Office Action Summary	Application No. 10/803,051	Applicant(s) PLANTAN, RONALD S.	
	Examiner Melody M. Burch	Art Unit 3683

DETAILED ACTION

2. Claims 1-9 are rejected under 35 U.S.C. 102(e) as being anticipated by WIPO 2004/026649 to Simmons.

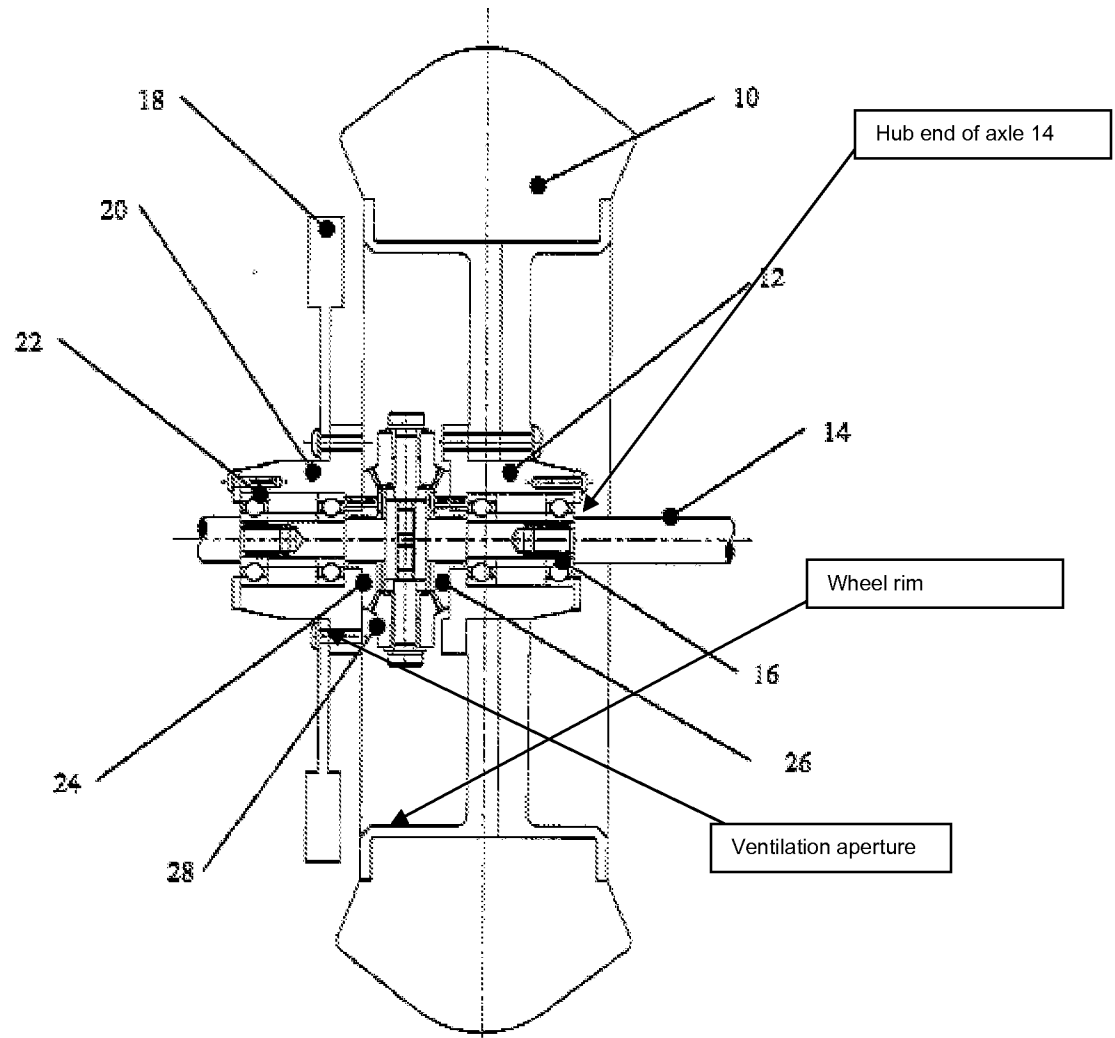
Re: claims 1-3. Simmons shows in figure 5 a brake disc 18 comprising a hub portion shown immediately to the left of the circle at the end of lead line 24, a friction portion shown in the area of the circle at the end of element number 18, the friction portion formed as a generally planar ring and a connecting flange portion shown in the area to the right of the circle at the end of the lead line for element number 20 wherein the connecting flange portion connects a radially outer region of the hub portion to a

radially inner region of the friction portion radially inward from a radially inner most friction surface of the friction portion, the connecting flange portion has a length such that when the hub portion and a wheel rim as labeled in the annotated version of figure 5 of Simmons provided in this Office action (see pg. 6) adapted to be mounted on a hub end as labeled of a vehicle axle 14 are concentrically located at the hub end of the axle, the friction portion is outboard of the wheel rim, and the friction portion has an outer radius greater than a greatest inner radius of the wheel rim as shown.

Re: claims 4-6. Simmons in figure 5 shows an at least one heat-conduction limiting section or reduced thickness shown at the bottom of the portion shown in the area of the end of the lead line of number "18".

Re: claims 7-9. Simmons shows in figure 5 at least one ventilation aperture as labeled in the annotated figure provided in this Office action.

Re: claims 17-19. Simmons, as modified, teaches in figure 5 of Simmons an at least one heat-conduction limiting section or reduced thickness shown at the bottom of the portion shown in the area of the end of the lead line of number "18".

Re: claims 20-22. Simmons, as modified, teach in figure 5 of Simmons at least one ventilation aperture as labeled in the annotated figure provided in this Office action.
